REMARKS

In the Office Action, the Examiner rejected Claims 1-6 and 10-18 over the prior art. Also, the Examiner objected to Claims 7-9 as being dependent upon a rejected base claim, and indicated that these claims would be allowable if appropriately rewritten. In addition, the Examiner objected to the specification, to the drawings, and to some of the language in the claims.

Figure 1

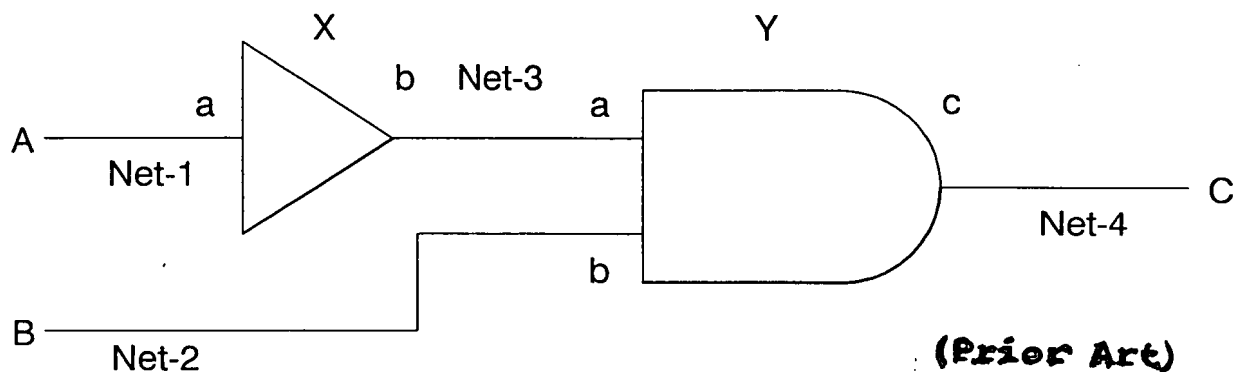
The Examiner objected to the drawings on the grounds that Figures 1-3 should be labeled as "Prior Art." Applicants are herewith submitting formal drawings for this application. It is noted that, in these formal drawings, Figures 1-3 are labeled "Prior Art," and the Examiner is thus also requested to reconsider and to withdraw the objection to the drawings.

Applicants ask permission to label Figures 1-3 as “Prior Art”, as shown on the attached Replacement and Annotated Sheets.

(Prior Art)
